RE: **700 Tijeras**
700 Tijeras Ave NW
Grading and Drainage Plan
Engineer's Stamp Date: 7/15/19
Hydrology File: K14D117

Based on the submittal received on 7/15/19, the Grading and Drainage Plan cannot be approved for Building Permit until the following corrections are made:

Re: Hydrology file #K14D117, 700 Tijeras NW

C-101

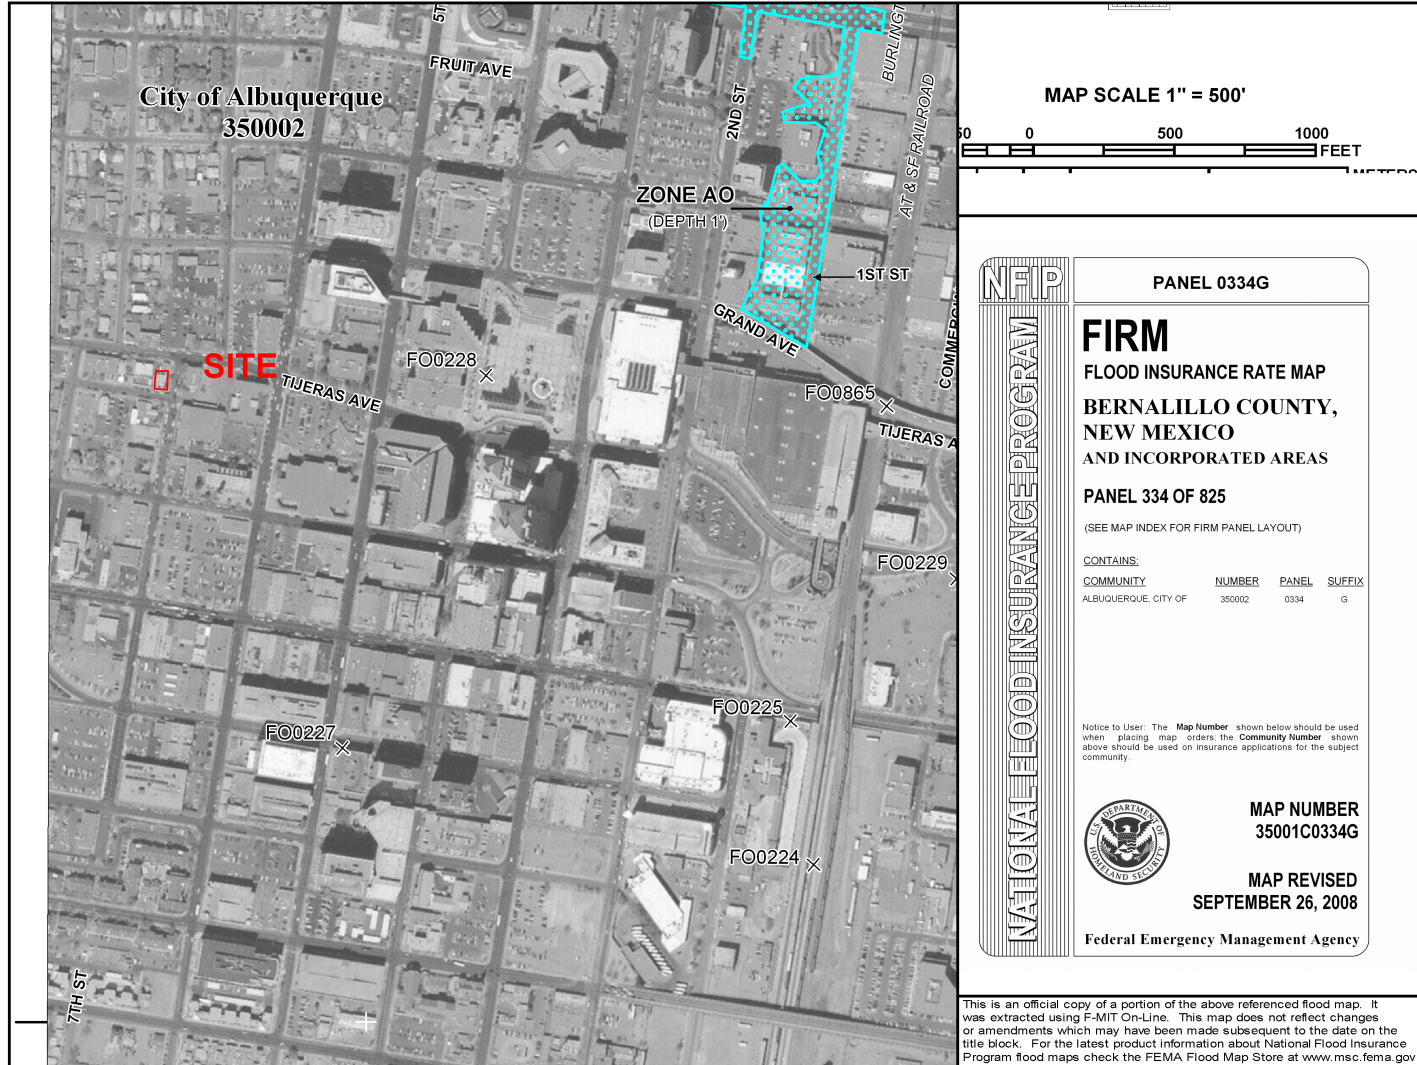
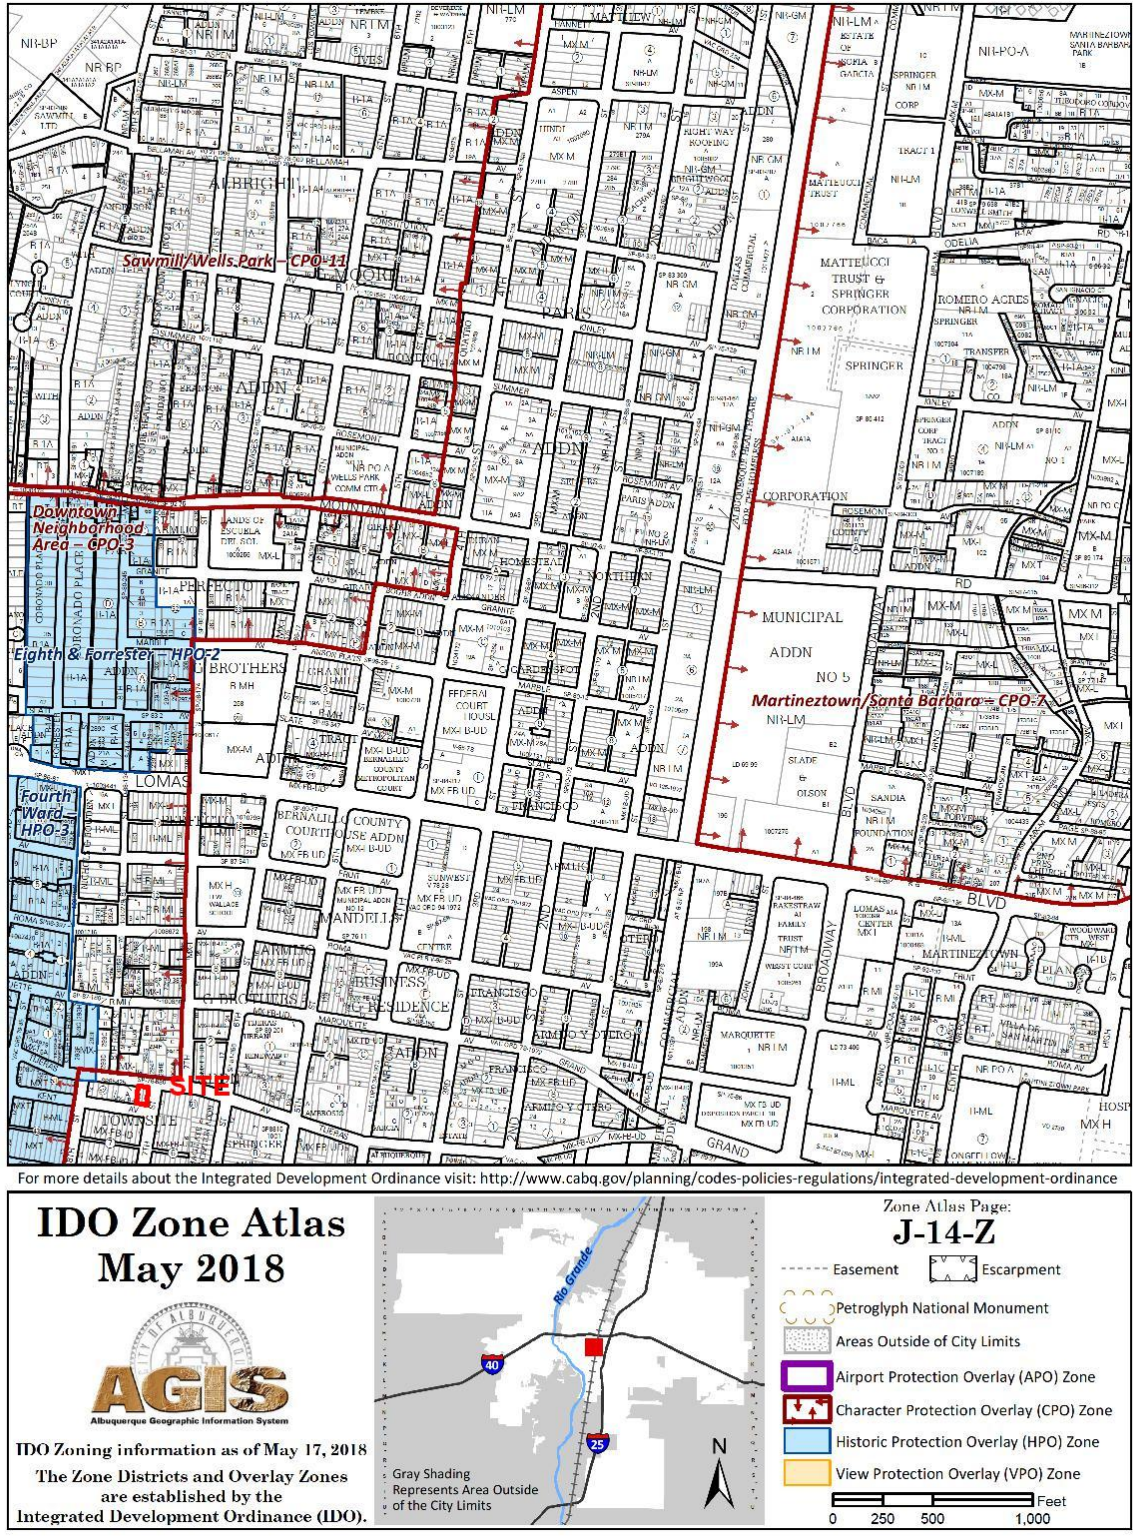
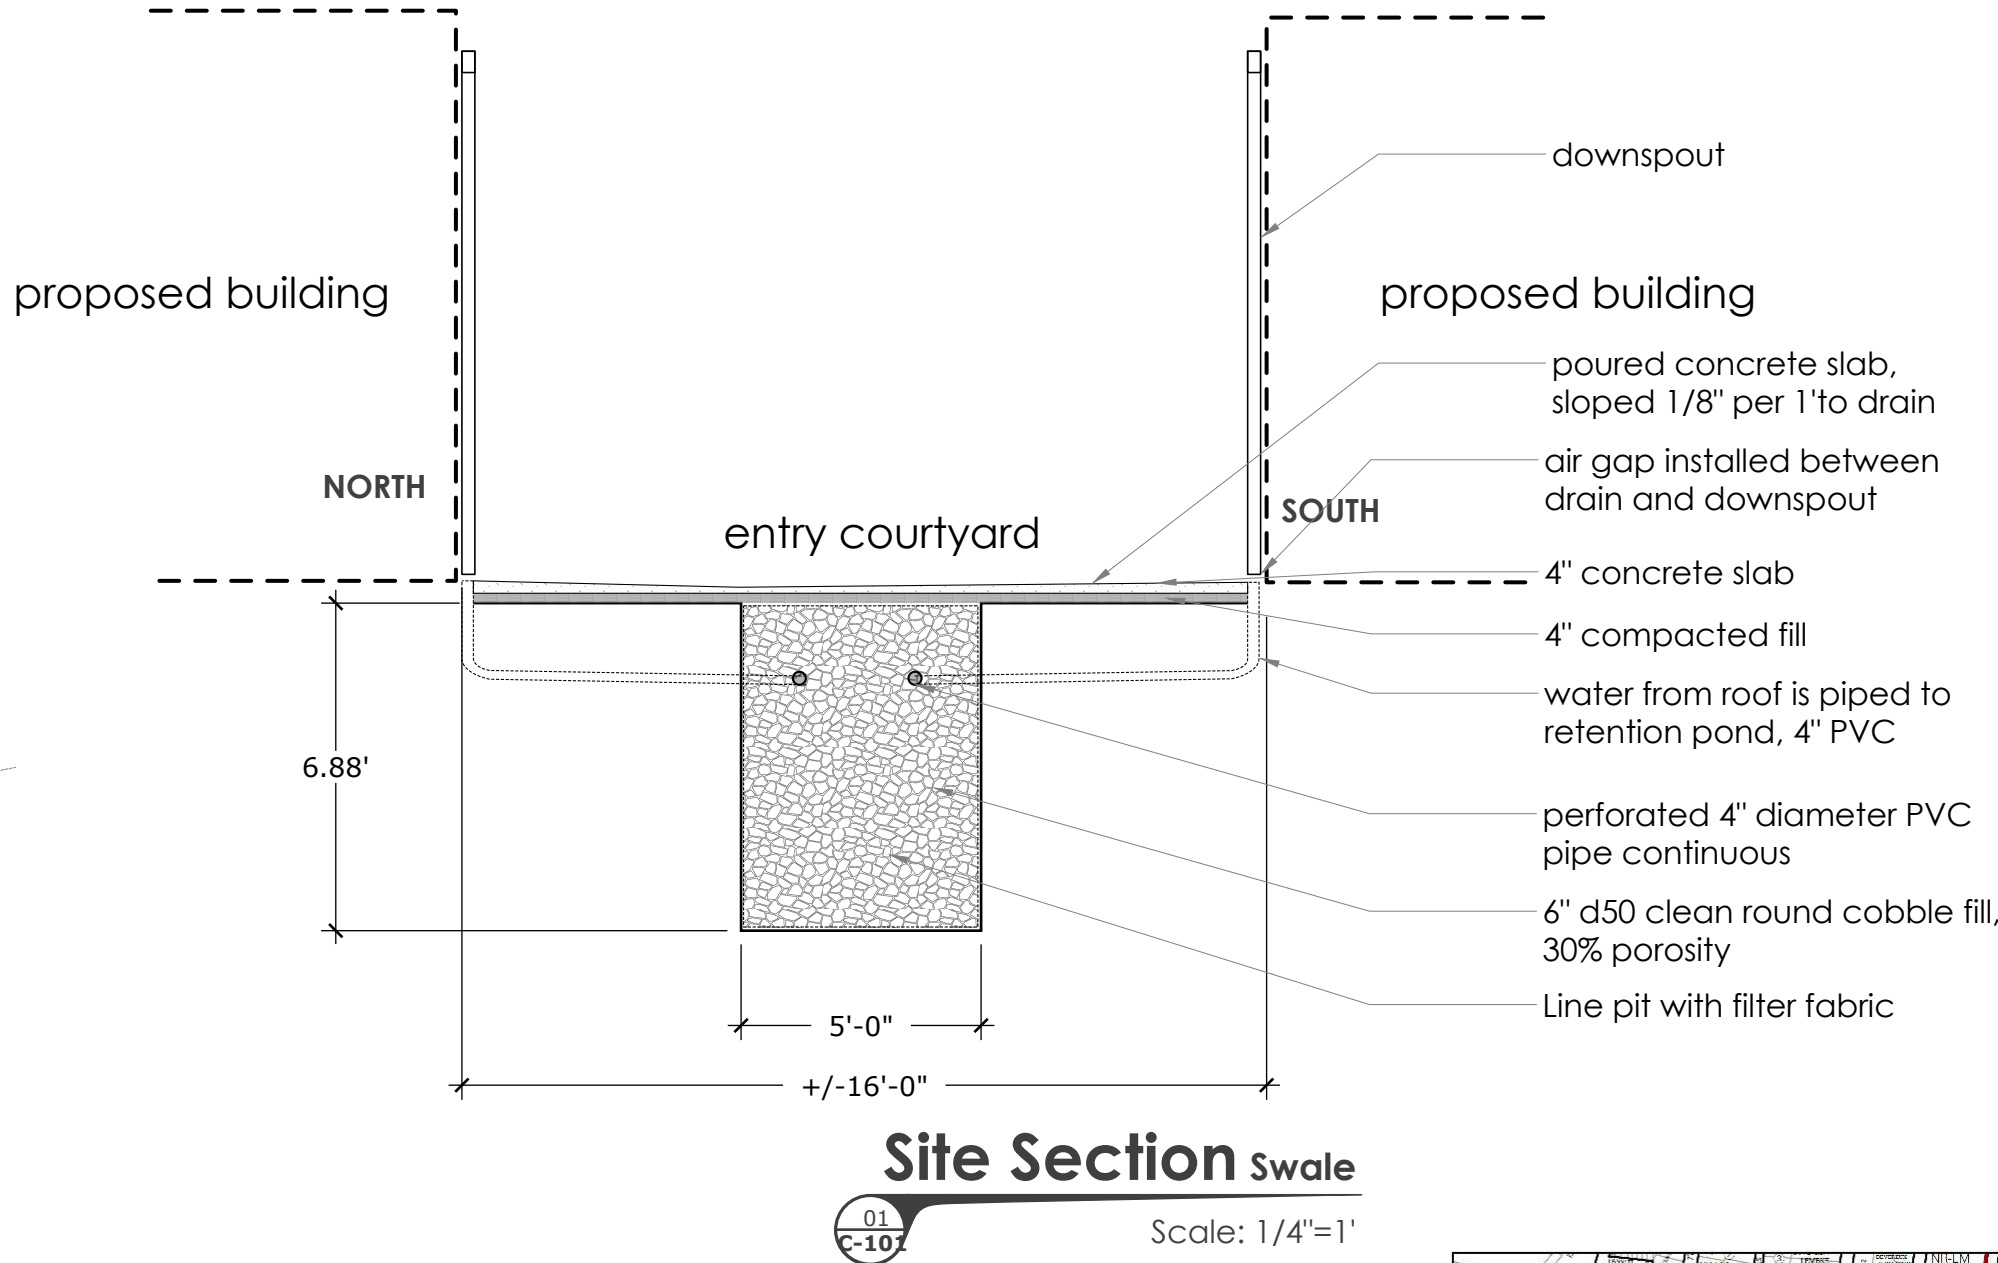
1. The temporary benchmark needs to be tied to a permanent monument, preferably part of the Albuquerque Geodetic Reference System (AGRS).
2. The drawing needs to be scaled to a common-use engineer's scale (not architect's) such as 1"=20' or 1"=10'.
3. For Information. This project will require a revocable permit for the balconies overhanging the ROW. Please contact the City Engineer (Shahab Biazar, sbiazar@cabq.gov) for more information.
4. Because these corrections are minor, the administrative resubmittal fee of \$40 may be used. Please include a copy of this letter when resubmitting in order to receive the reduced fee.

2. Include project benchmark and datum. *This has been added to the plan.*
3. Provide existing site topography and label existing and proposed contours. Since the site is extremely flat, please provide spot elevations (existing and proposed) in enough density to verify the drainage areas and outfalls that you have indicated. Also include the finished floor elevation of the buildings. *2018 LIDAR 1' contours have been added to the plan along with existing spot elevations for the top of curb.*

5. Include the finished elevation for the courtyard slab and show how it will drain with slopes and spot elevations. It seems to drain to the middle, then east towards the trench drain, but this is unclear on the plan. *This information has been provided on the plan.*

- entry courtyard: concrete
- downspout
- concrete patio sloped to trench drain
- trench drain placed in concrete at specified location
- water piped from trench drain to retention pond
- retention pond, see detail
- water off roof is piped to retention pond from downspout
- downspout
- concrete patio sloped to trench drain

elevations are NAVD 1988, project benchmark square cut @ SW corner of hydrant pad EL: 4955.76
